**SKEWED ABUTMENT PLAN WITH WING EXTENSIONS**  
(SKEWED LEFT AHEAD SHOWN, SKEWED RIGHT AHEAD SIMILAR)

LATEST REVISION DATE 04-12	APPROVED BY BRIDGE ENGINEER <i>Norman E. McQuinn</i>		
		STANDARD DESIGN - 24' ROADWAY, THREE SPAN BRIDGE <b>PRETENSIONED PRESTRESSED CONCRETE BEAM BRIDGES</b> DECEMBER, 2006	
		<b>ABUTMENT BACKFILL DETAILS</b> C BEAMS - SKEWED	<b>H24-84-06</b>

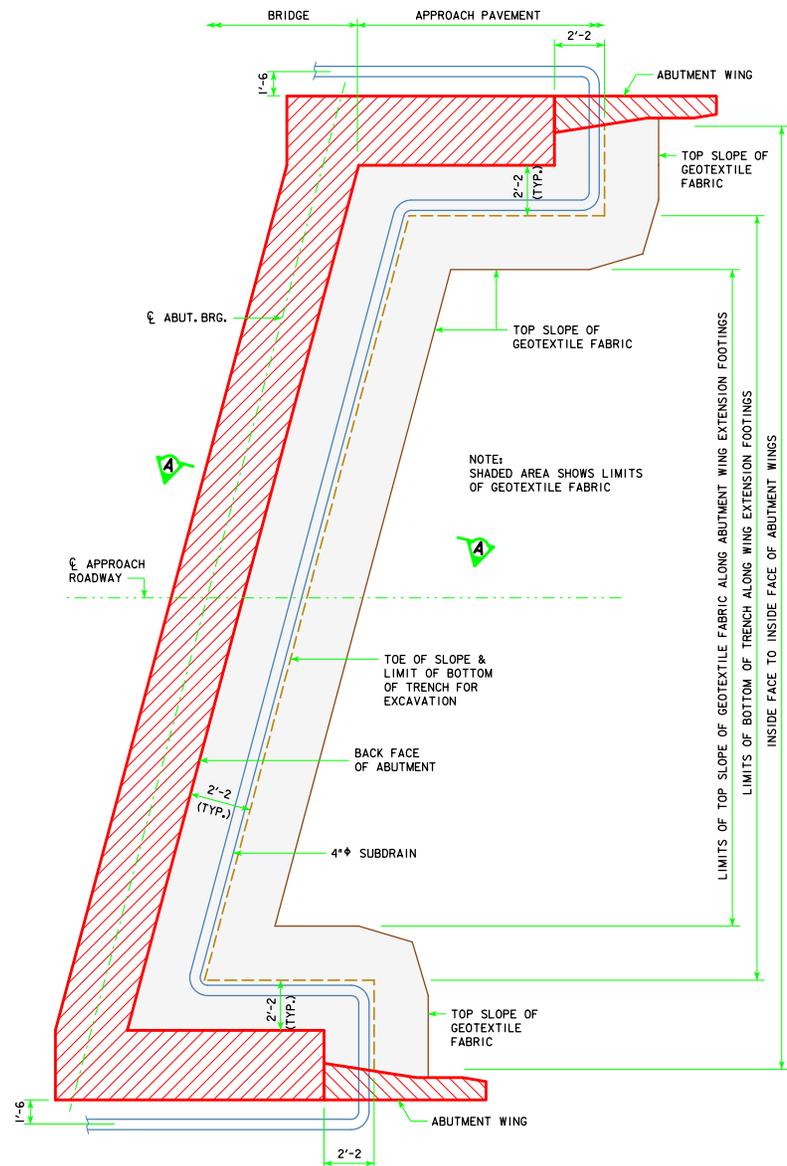
REVISED 04-12 - EXCAVATION LIMIT ON THE FRONT FACE OF THE ABUTMENT WAS CHANGED TO A 3'-0" LIMIT. THE APPROACH FILL WAS IDENTIFIED AS THE GRADING SURFACE.
